Access Compliance Report

Public Rights-of-Way

(Curb Ramps)

Intersection ID: 18534	Main Street: COLONY_RD	Cross Street: ROCKBROOK_DR	Location: SE
ADA ID: 04F198F8D8DC	Ramp Type: PerpDiag	Initial Pass/Fail: Fail	Overall Compliance: No
		Severity Score: 25

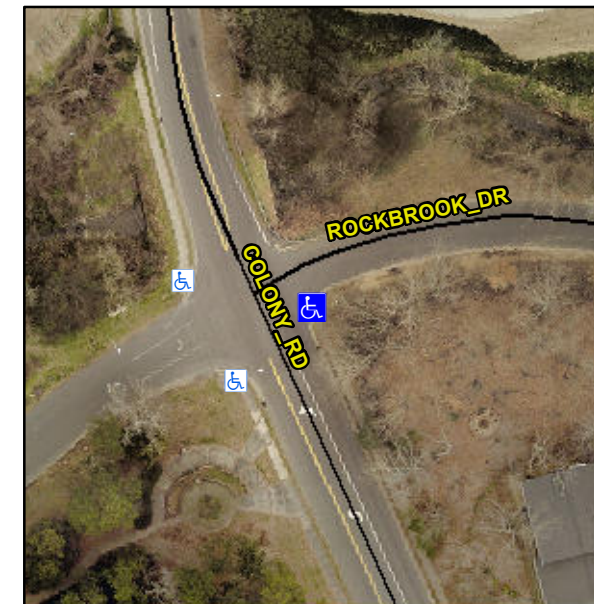
Not Found, R304.2.2, R304.5.3

Compliance	Description	Data	Compliance	Description	Data
N/A	Ramp Length (in)	79.0	No	Ramp Slope (%)	10.8
Yes	Ramp Width (in)	56.0	No	Ramp XSlope (%)	5.6
N/A	Flare Type LT	N/A	N/A	Flare Type RT	N/A
N/A	Flare Slope LT (%)	N/A	N/A	Flare Slope RT (%)	N/A
N/A	Flare Traversable LT?	N/A	N/A	Flare Traversable RT?	N/A
N/A	Landing Length (in)	N/A	N/A	DWS Provided?	N/A
N/A	Landing Width (in)	N/A	N/A	DWS Contrast?	N/A
N/A	Landing Slope (%)	N/A	N/A	DWS Length (in)	N/A
N/A	Landing X Slope (%)	N/A	N/A	DWS Full Width?	N/A
N/A	Landing Curb? (Y/N)	N/A	N/A	DWS Offset (in)	N/A
N/A	Shared Landing?	N/A			
N/A	Gutter Ponding?	N/A	N/A	Gutter Slope (%)	N/A
N/A	Gutter Lip Ht (in)	N/A	N/A	Gutter X Slope (%)	N/A
N/A	Painted X Walk1?	No	N/A	Painted X Walk2?	No
	X Walk 1 Direction	To NW		X Walk 2 Direction	To SW
N/A	X Walk 1 Width (in)	N/A	N/A	X Walk 2 Width (in)	N/A
	X Walk 1 Slope (%)	6.7		X Walk 2 Slope (%)	4.0
	X Walk 1 X Slope (%)	1.2		X Walk 2 X Slope (%)	4.8

Remove & Replace Curb Ramp With Two New Directional Ramps or Equivalent.
